DUKE POWER COMPANY
OCONEE NUCLEAR STATION

Proposed Technical Specification
Revisions for Unit 3, Cycle 6 Operation
(Supplement to August 25, 1980 Submittal)

OCONEE NUCLEAR STATION
 Figure 3.5.2-1C1

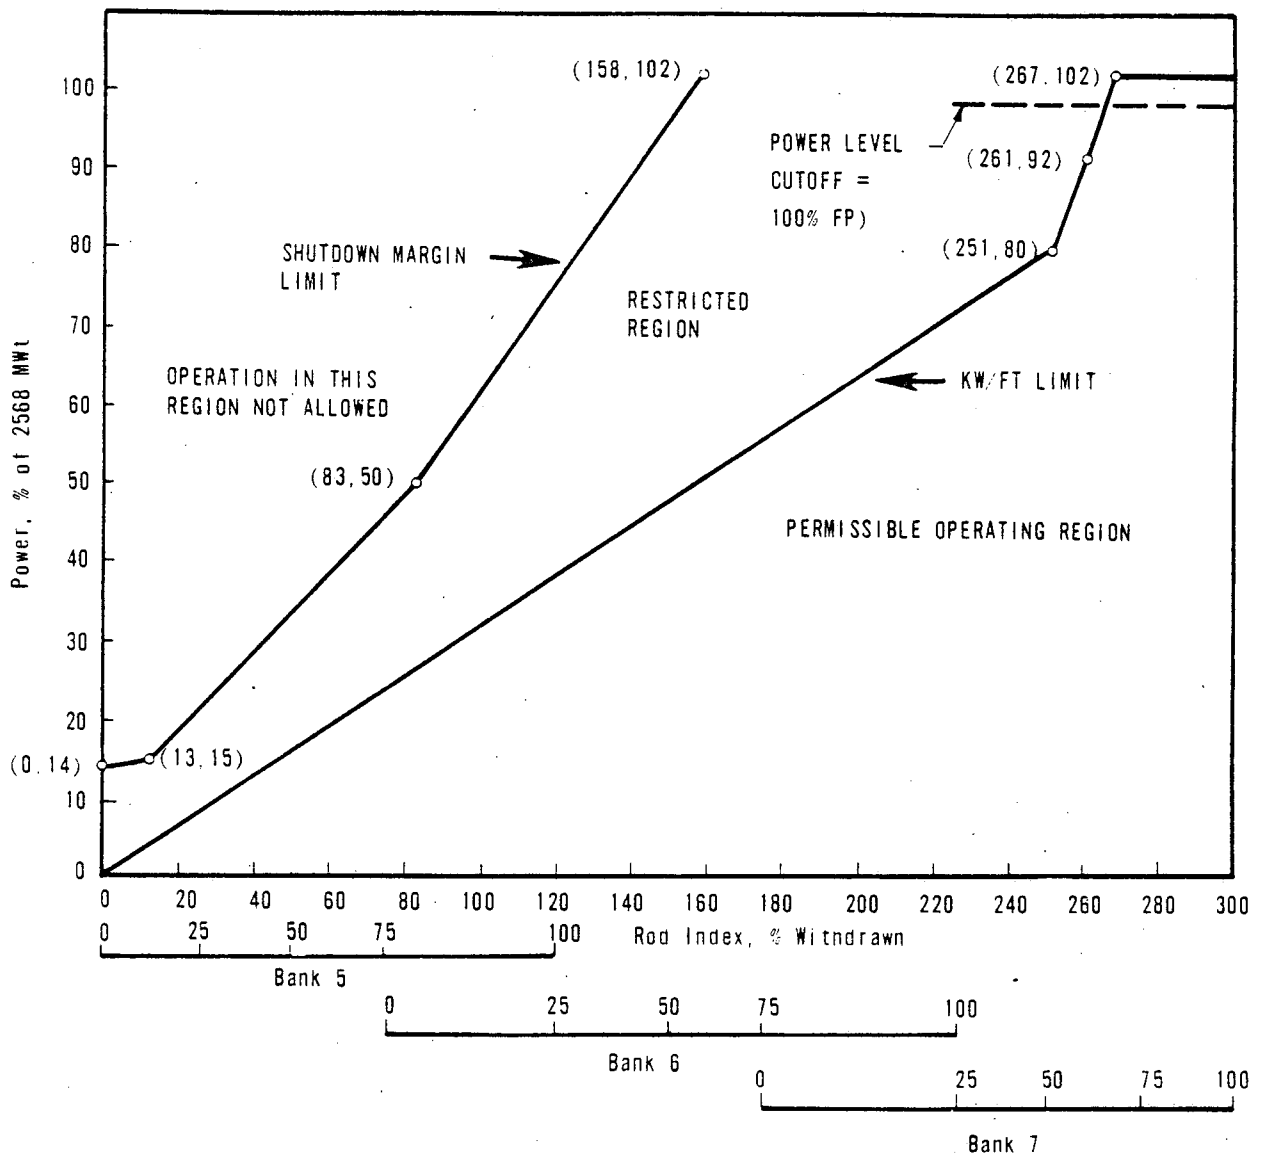
ROD POSITION LIMITS
 FOR FOUR-PUMP OPERATION
 FROM 0 TO 50 (+10, -0) EFPD
 UNIT 3

OCONEE NUCLEAR STATION
Figure 3.5.2-1C2

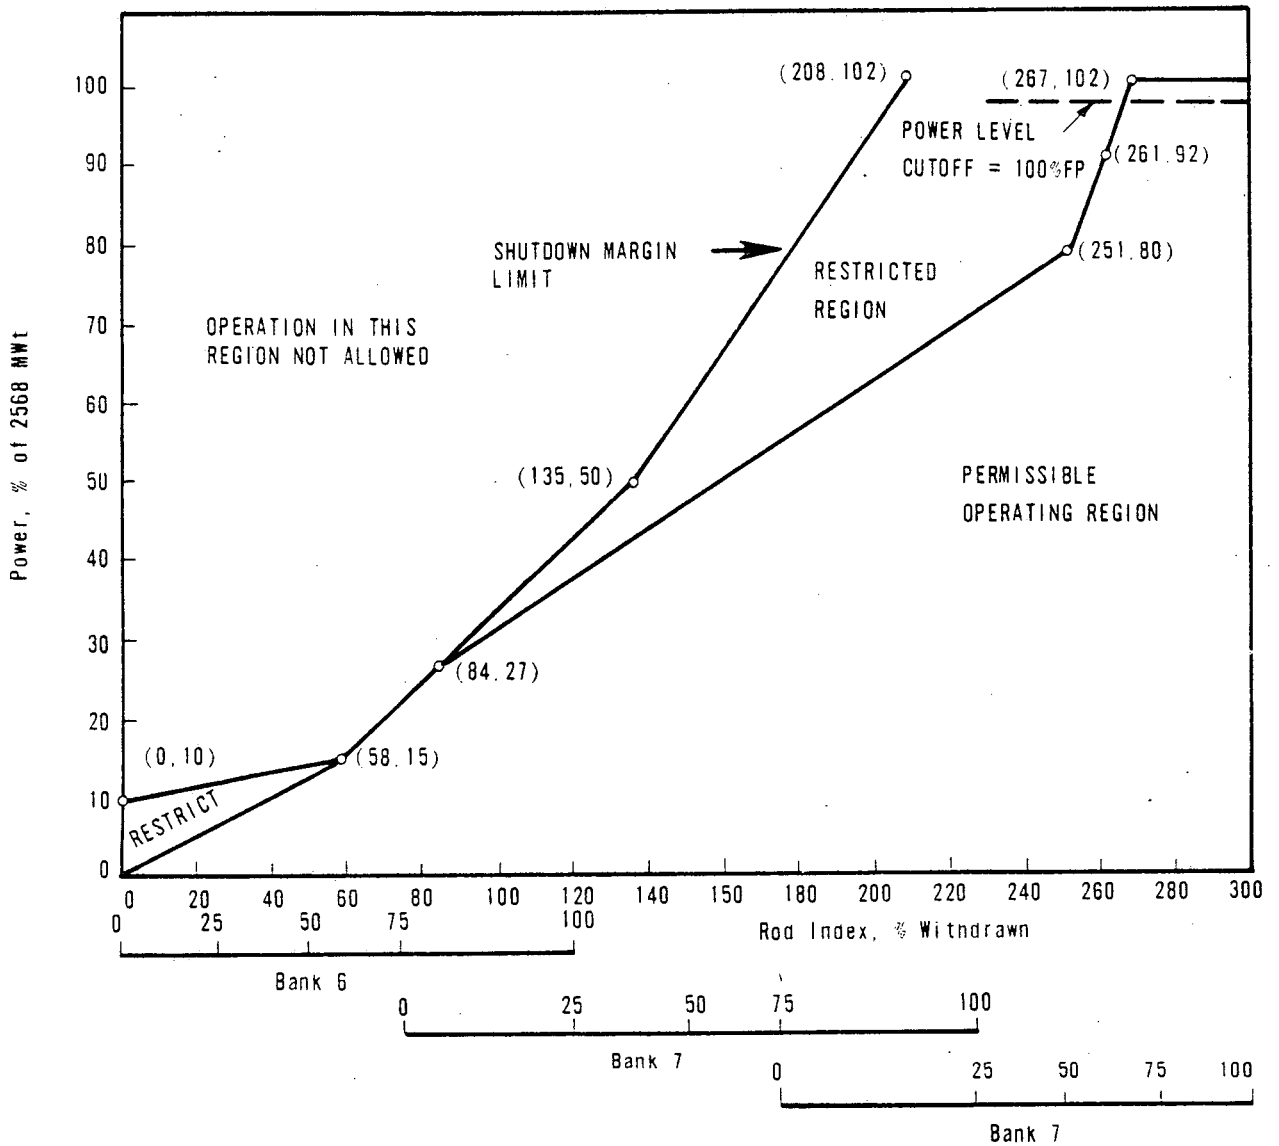
ROD POSITION LIMITS
FOR FOUR-PUMP OPERATION
FROM 50 (+ 10, -0) TO 200 (+ 10) EFPD
UNIT 3

OCONEE NUCLEAR STATION
 Figure 3.5.2-3C1

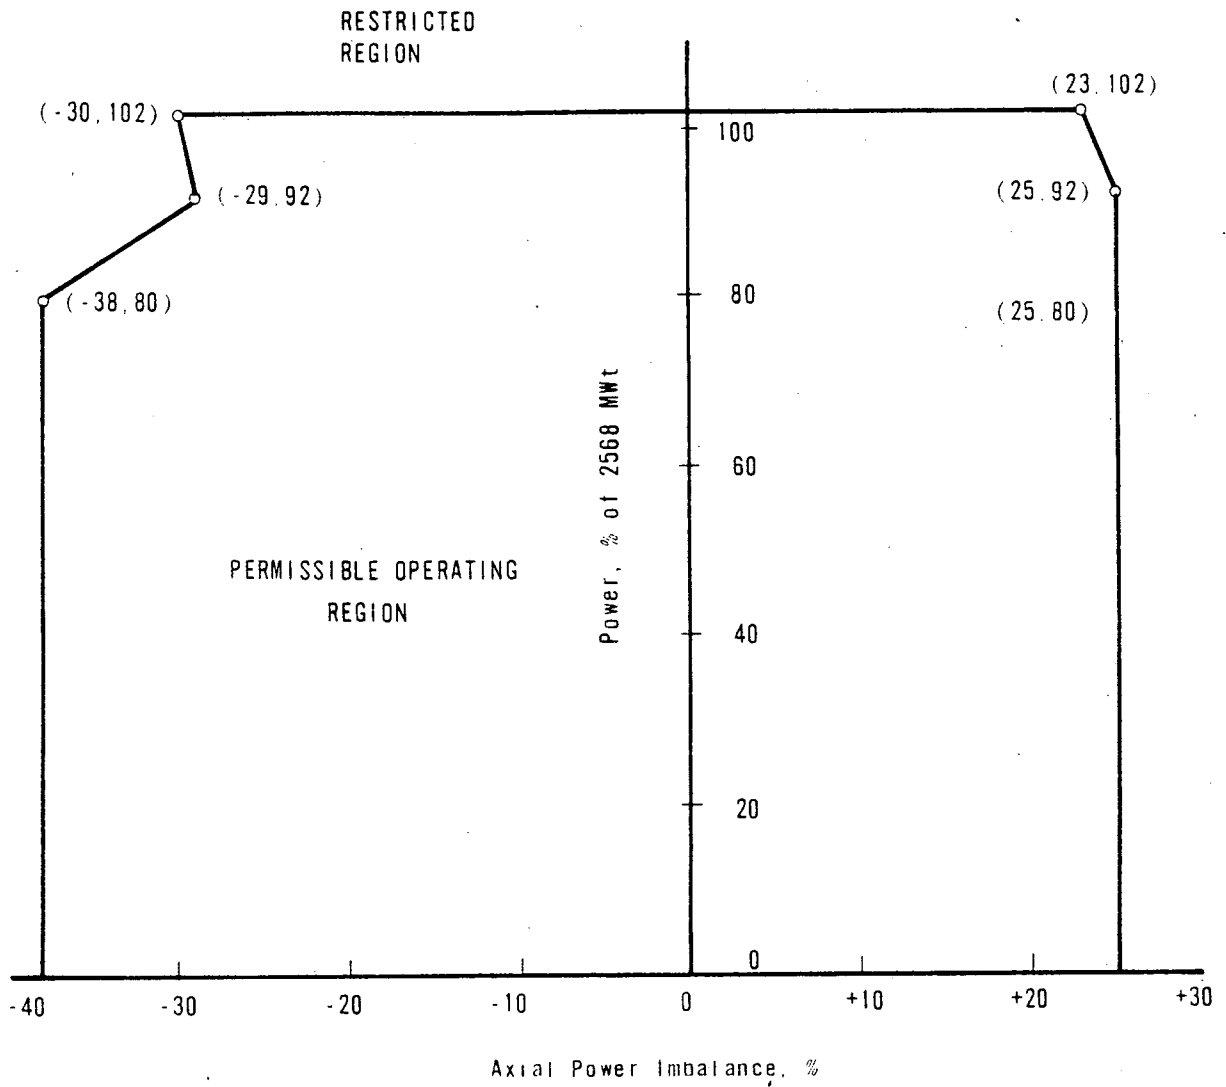
OPERATIONAL POWER
 IMBALANCE ENVELOPE
 FROM 0 TO 50 (+ 10, -0) EFPD
 UNIT 3

Figure 3.5.2-3C3

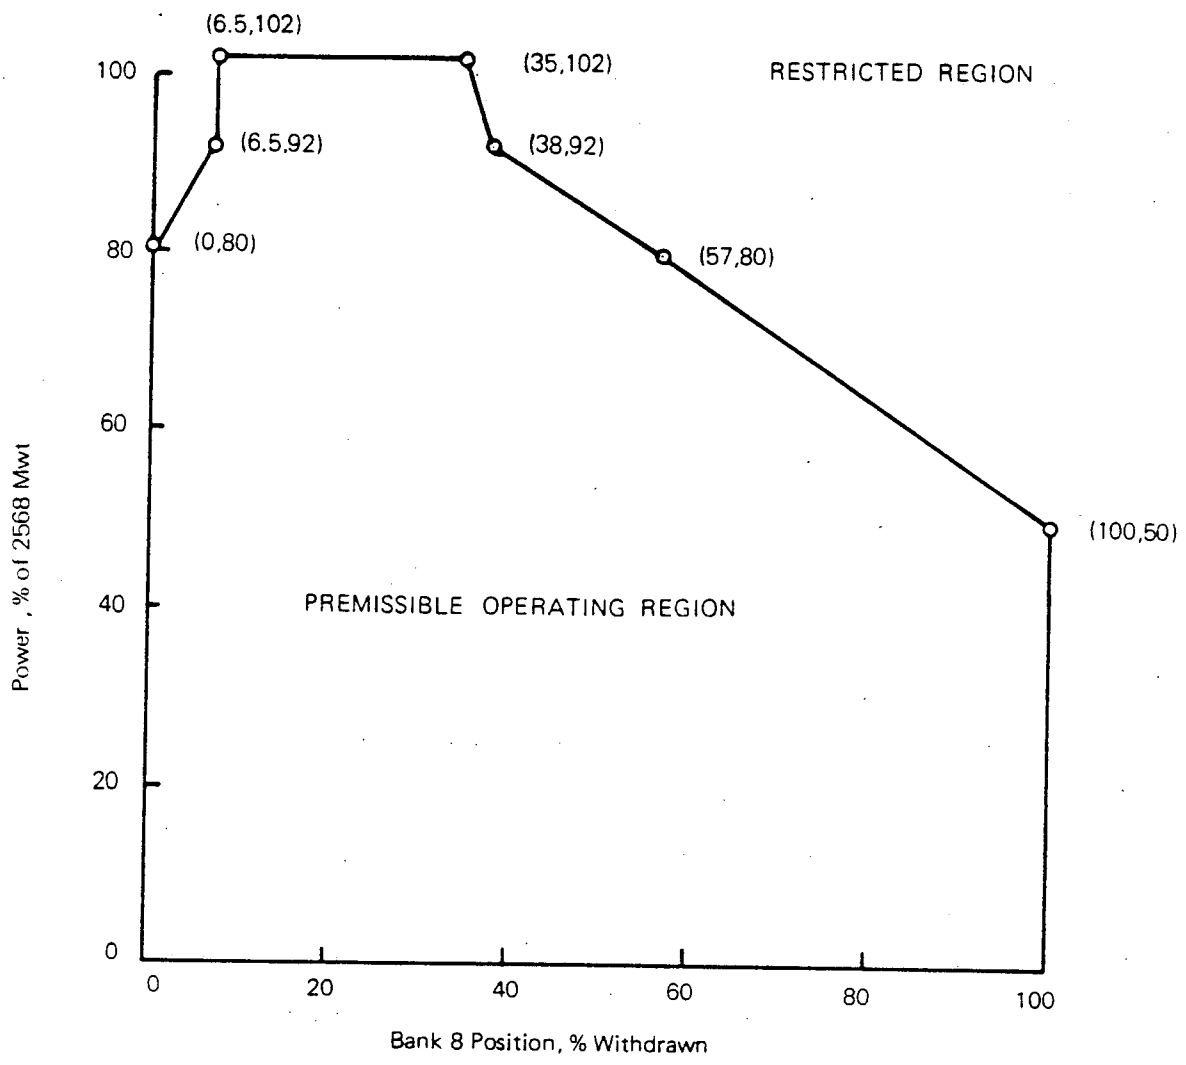
Deleted During Oconee Unit 3, Cycle 6 Operation
